TB CARE I

TECHNICAL ASSISTANCE FOR RENOVATION OF MDR-TB WARD AT  
MULAGO HOSPITAL

ENVIRONMENTAL/ENGINEERING REPORT

GROUND FLOOR PLAN- FEMALE WARD

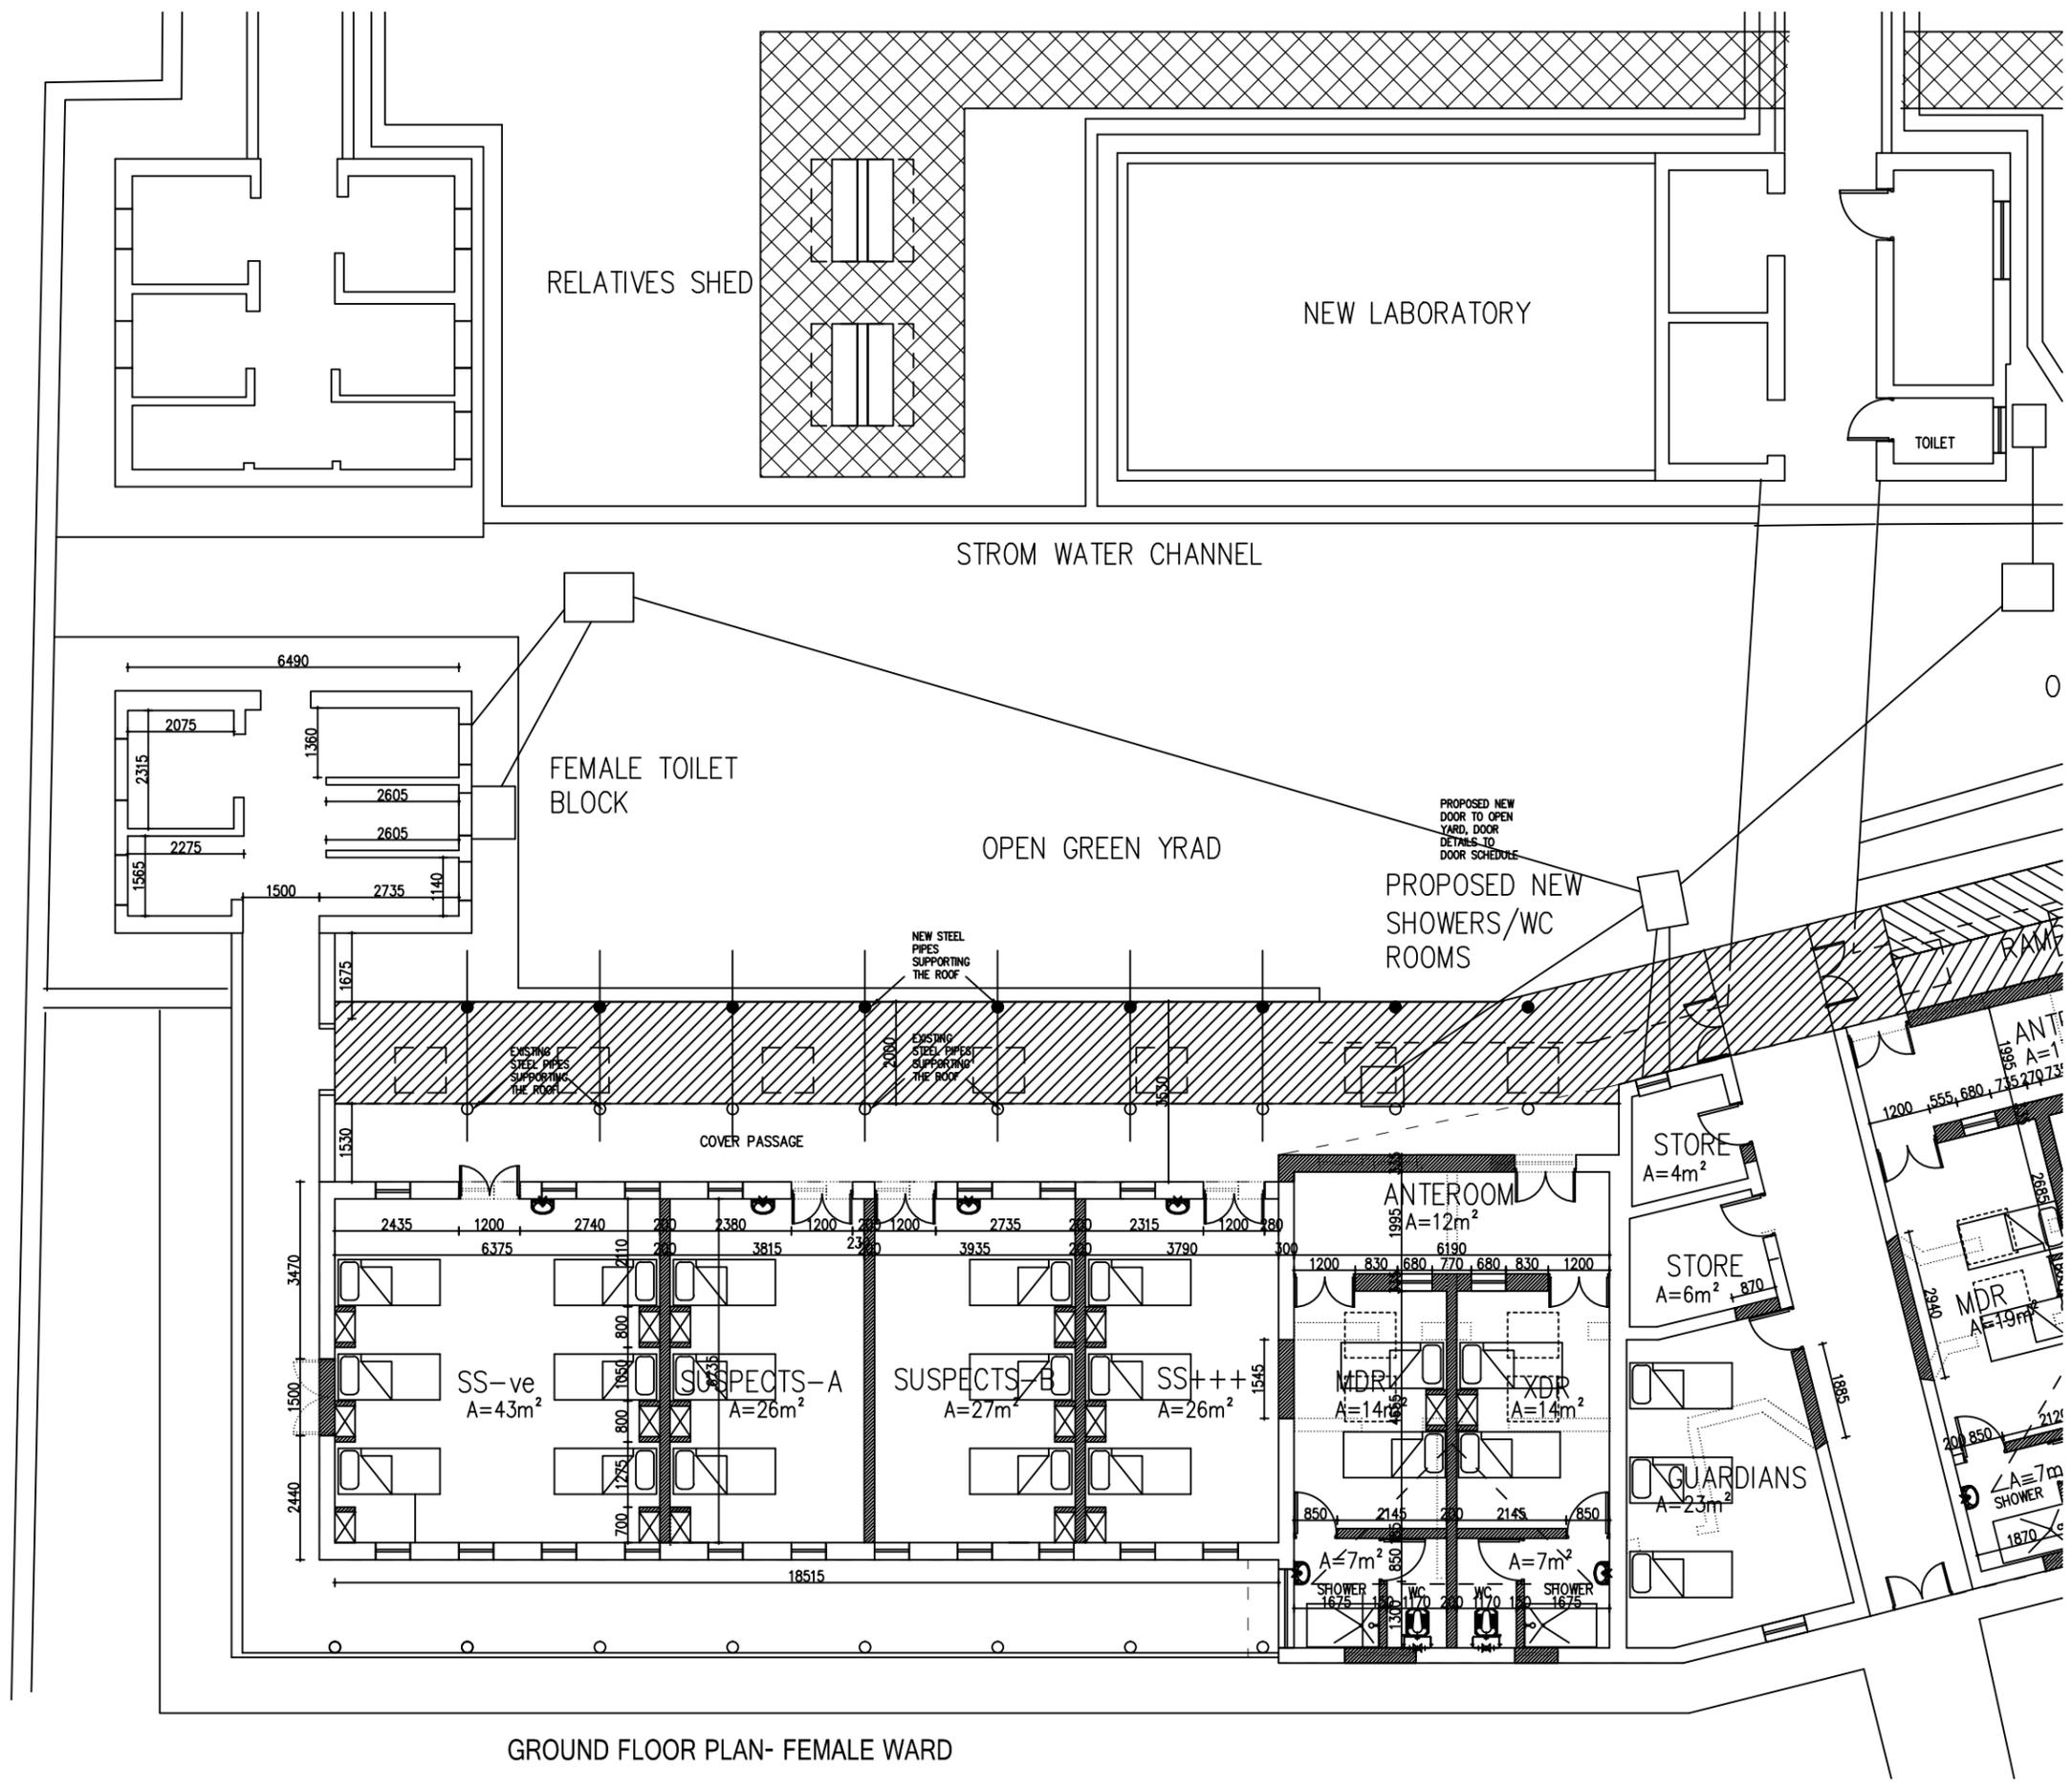
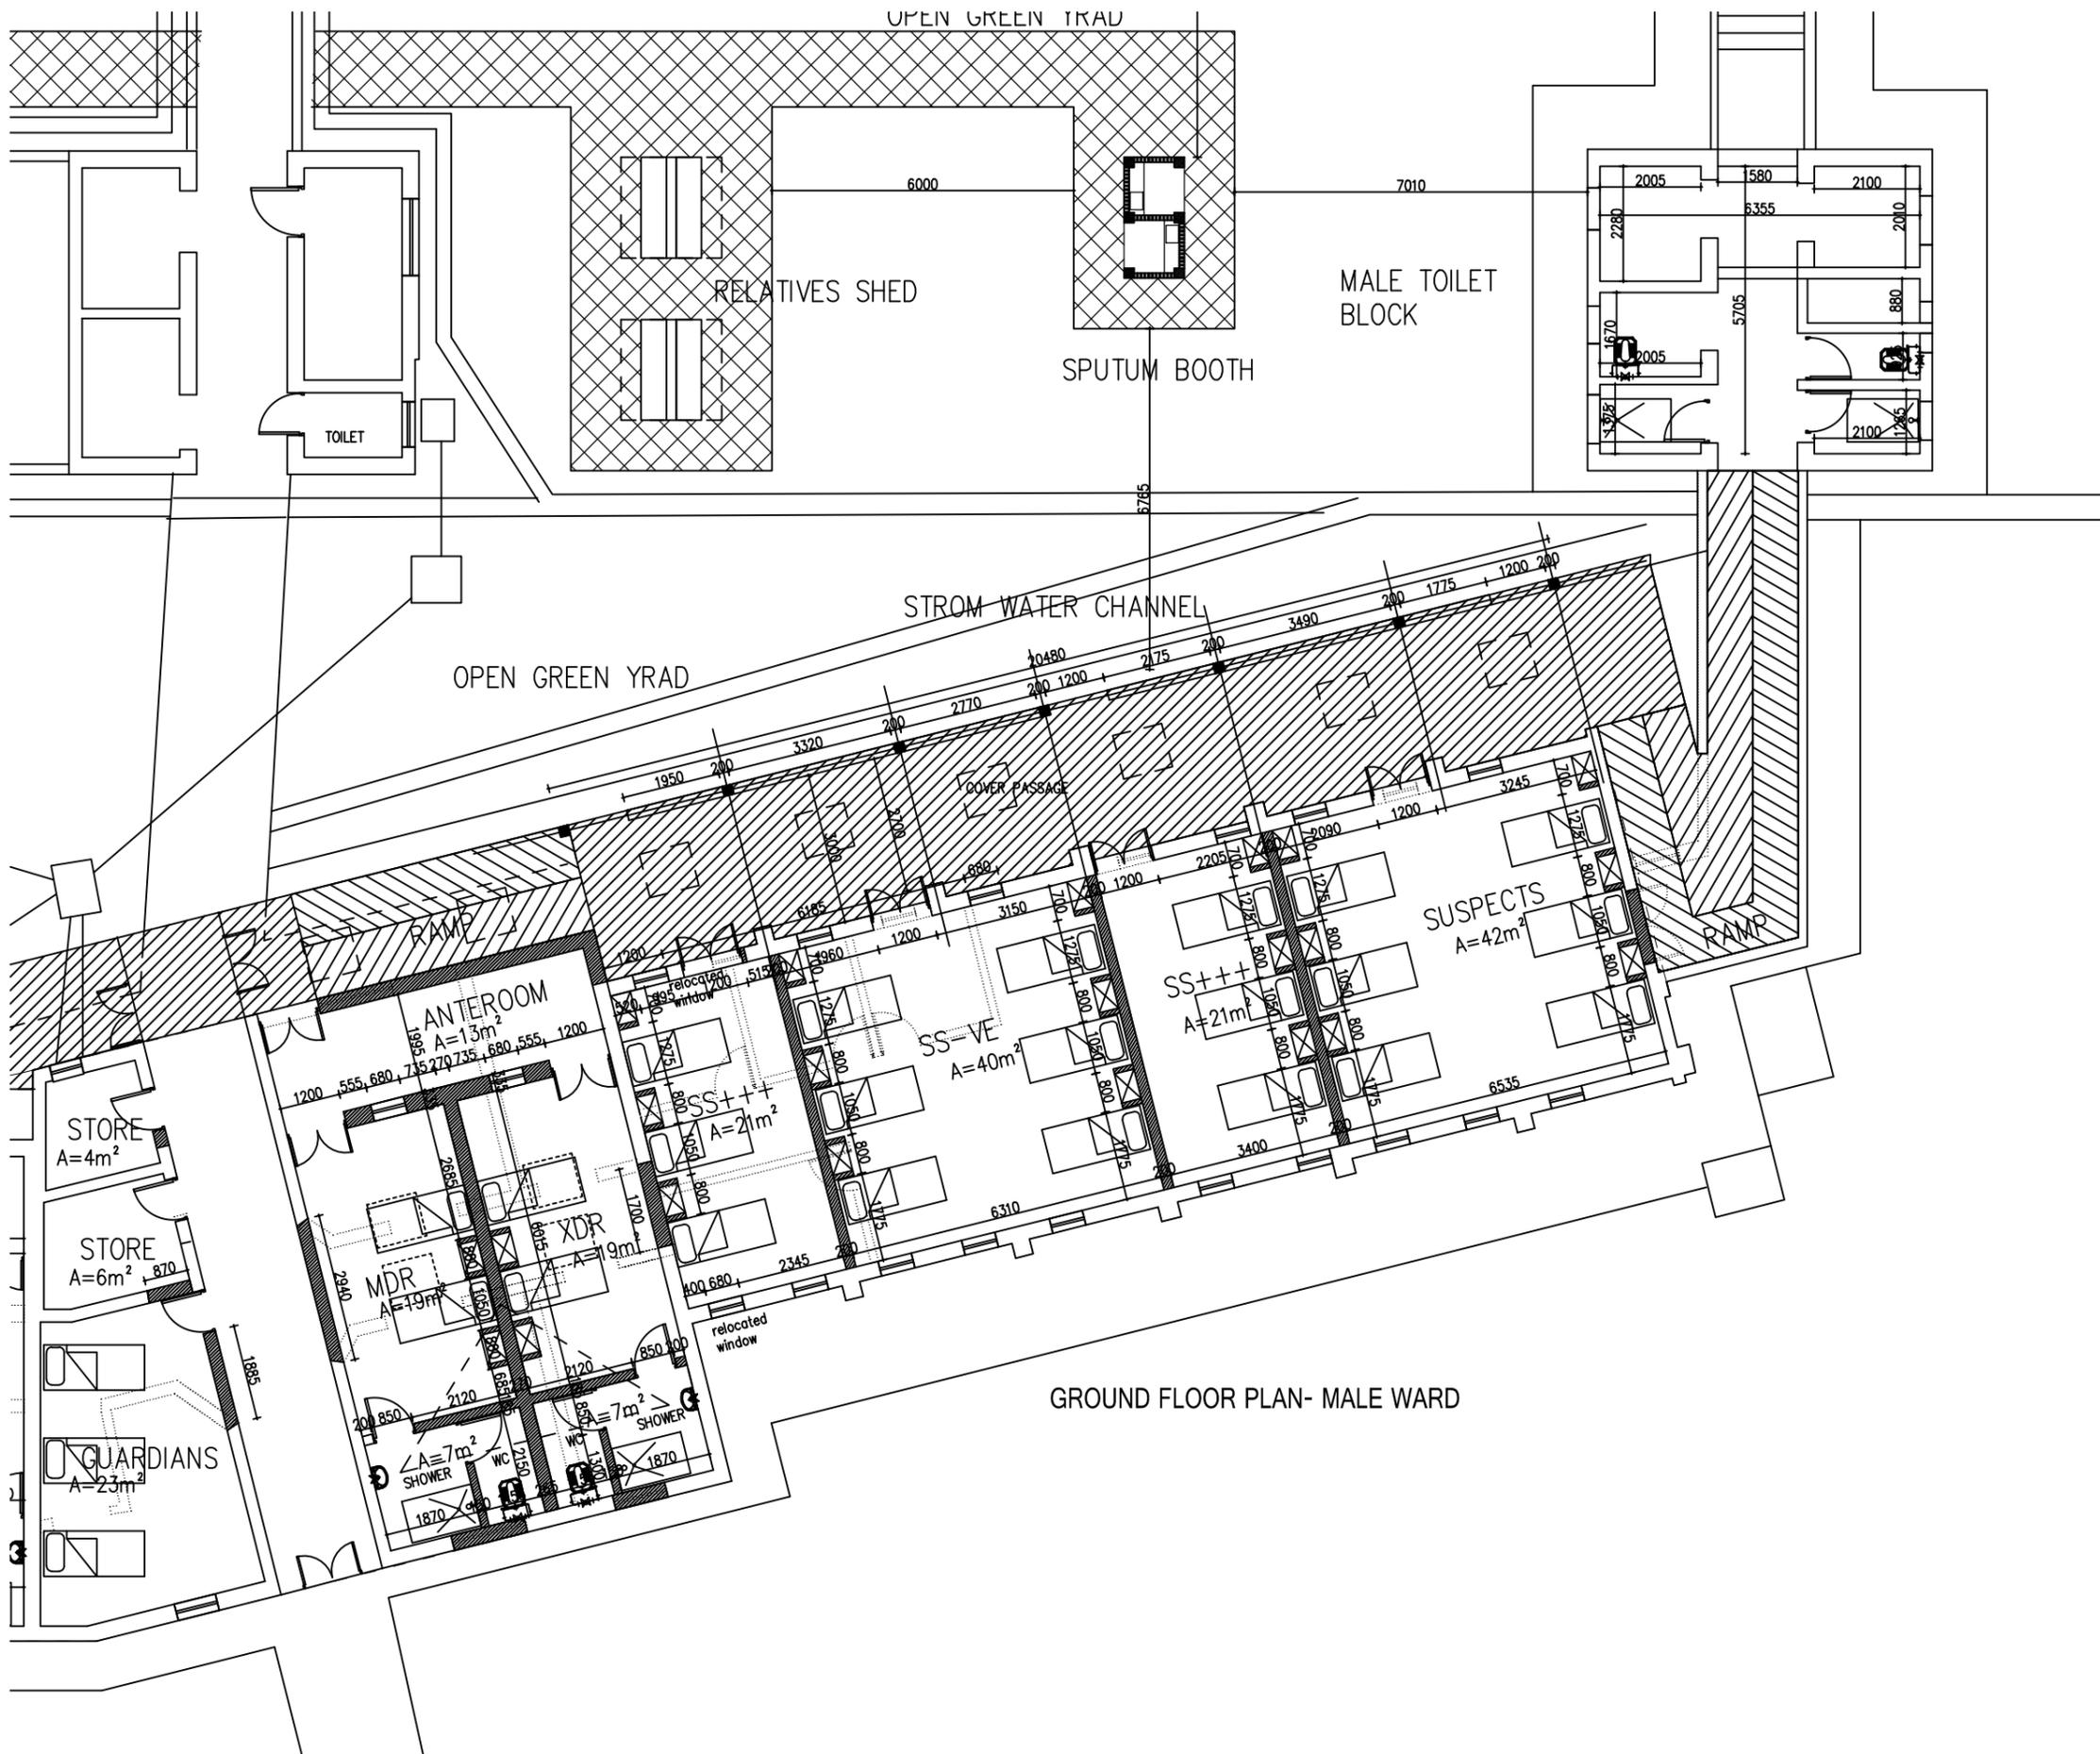
The existing walk way around the Female ward measuring 130cm wide (clear distance) is proposed to serve as a circulation area, but it is smaller than the minimum standard width of 180cm for a one way corridor. Therefore a full 2m wide corridor is planned in addition to the existing corridor for circulation. The existing corridor space will be used for patients' day area- an open shades space which is an extension of their indoor ward rooms. It is preferable that this corridor be covered with the same iron sheet roof material as that used for the existing buildings but with a shallower slope to allow head room in the added open corridors. As a result, 170m<sup>2</sup> of ground floor slab will be constructed for the additional external corridor. Part and parcel of this additional circulation area are ramps that are used to reconcile the level difference.

Ward Capacity is proposed to accommodate- 22 male and 19 female beds including isolation rooms. Increasing beyond this could possibly compromise infection control. It is proposed to use built-in ward robes between beds to dictate/suggest bed layout. Most of the built in cabinets will be 2m(H) x 60cm(W) x 40cm(D), but in areas where it is close to an existing window the height will be reduced to below window sill level. A total of 33 of them are proposed. Maintain a clear distance of at least 120cm between foot of beds and other structures and 90cm between beds and between beds and walls in furnishing the wards. Ensure that, this is also maintained throughout the operation of the facility.

### **SS-ve room, Suspects- A, Suspect-B, and S+++**

- Provide partition walls reaching up to the roof surface not to allow any cross flow of air among the wards
- Adjustable ventilation metal louvers one in each of three bed wards and two in each of the six bed wards.
- Carefully remove two 150cm wide door for possible re-use, construct wall to fill the resulting voids.
- Carefully remove windows with designation of W2 for reuse in their modified form in the bath rooms of the isolation rooms.
- Built in cabinets with as explained above.
- Supply and installation of hand wash basin with ceramic backing on the wall as shown on the floor plan.

### **MDR/XDR Rooms**

- Even out the variable floor levels so that these rooms will be the same level as female ward.
- Anteroom enclosed by air brick wall, care has to be exercised to maintain wall parts that are essential for structural support
- New partition walls defining the wards and the bath rooms
- Dormer louvered opening on the roof to enable cross ventilation above the roof of the bath room.
- Four built in cabinets in this case shared between two patients.

REFLECTED CEILING PLAN- FEMALE WARD

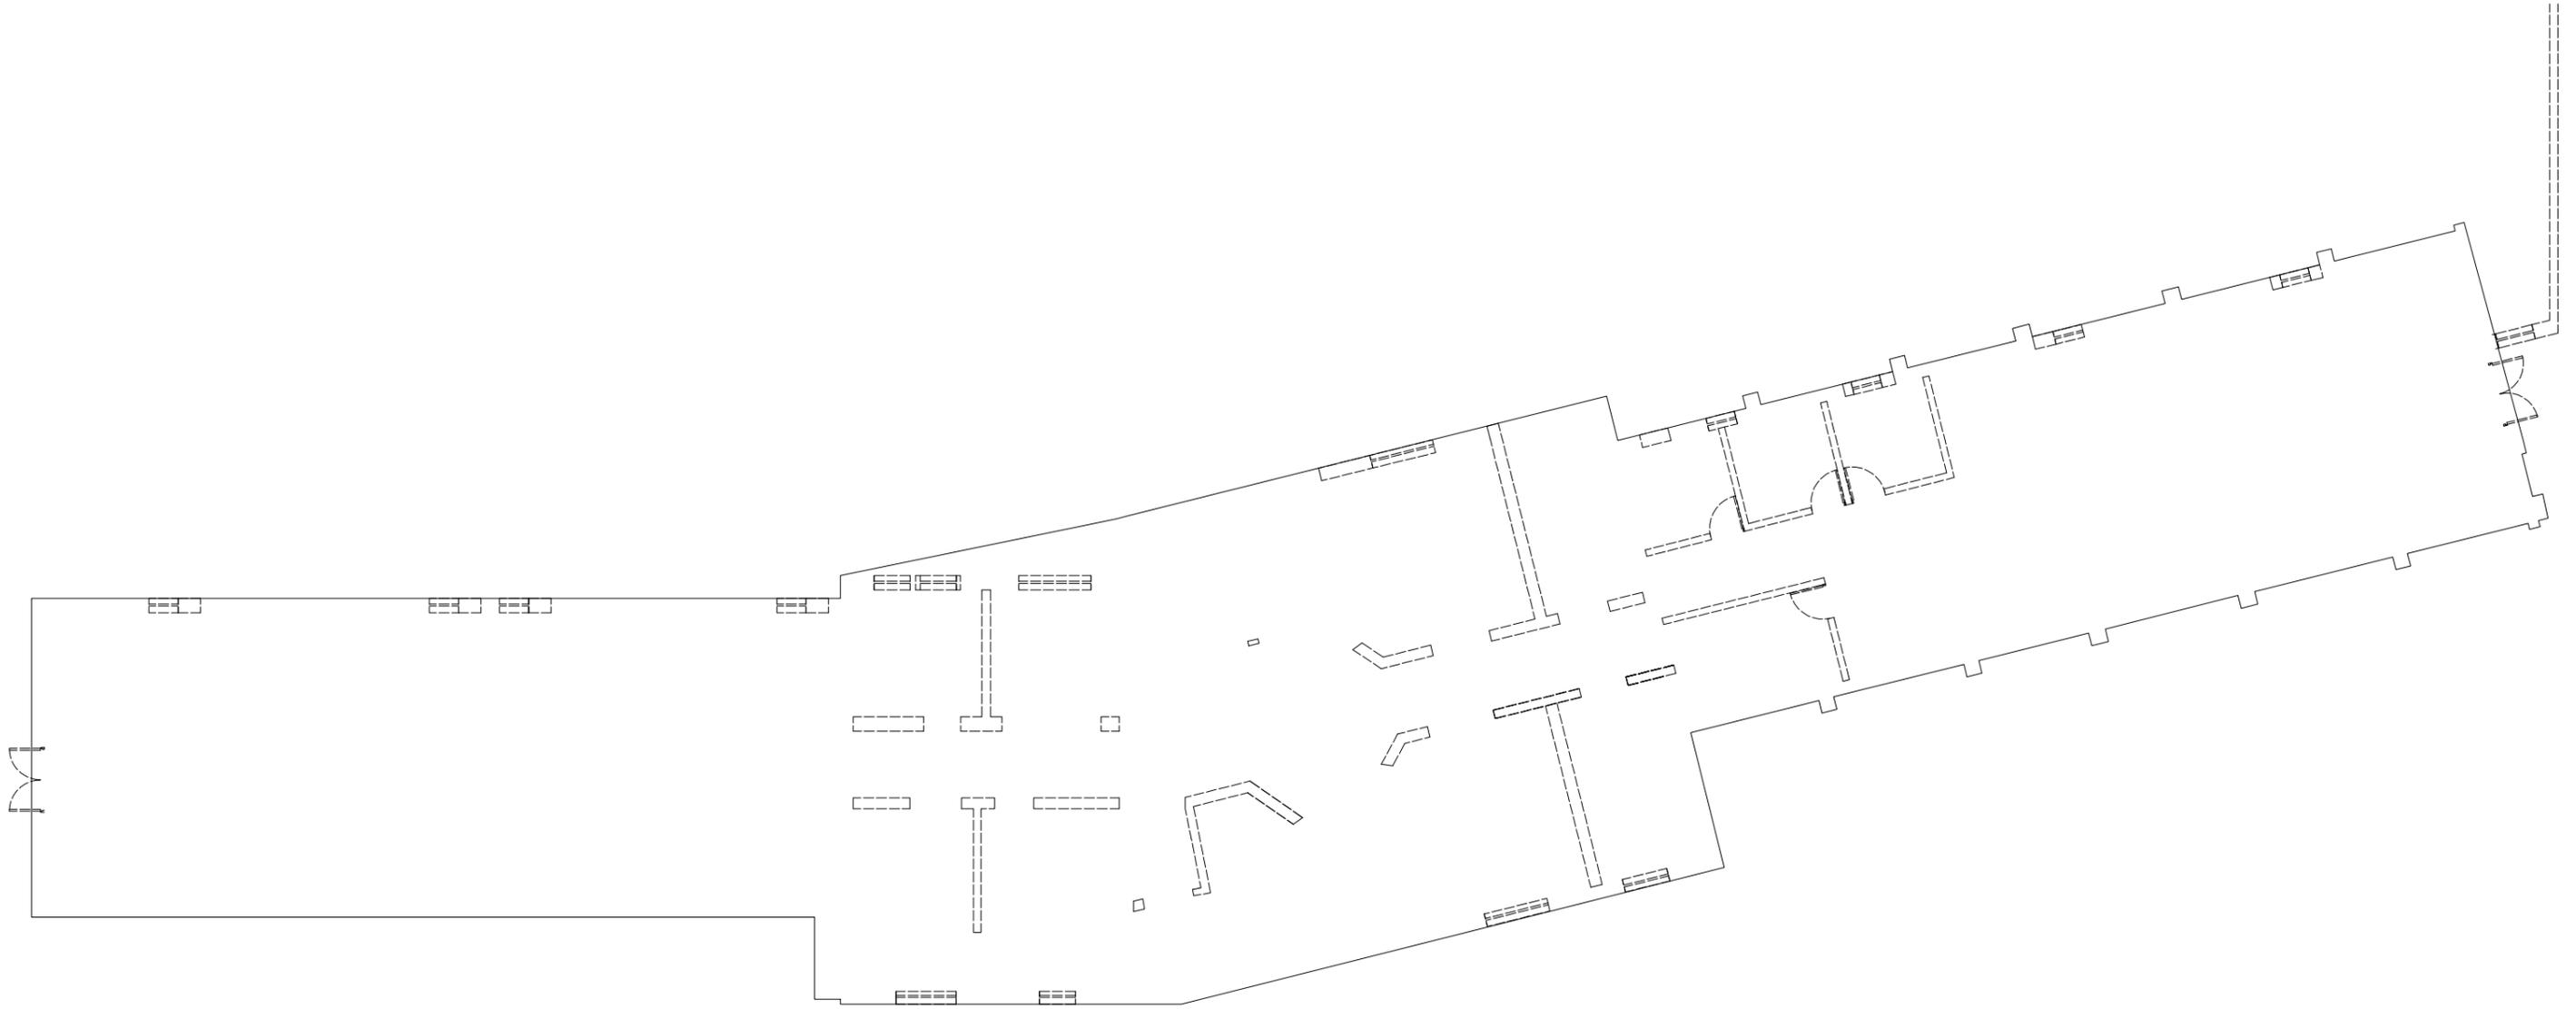
There is no need of ceiling in the male ward; the exposed wooden structural truss and wooden ceiling surface after surface preparation can be varnish coated to bring out its natural beauty. For the female ward replace ceiling materials.

Provide also metal louvers of size 20 x 20cm on every bay between the truss elements on the horizontal surface of the ceilings. These are the openings which will help the accumulated hot air to escape to the ridge ventilation above through stack effect.
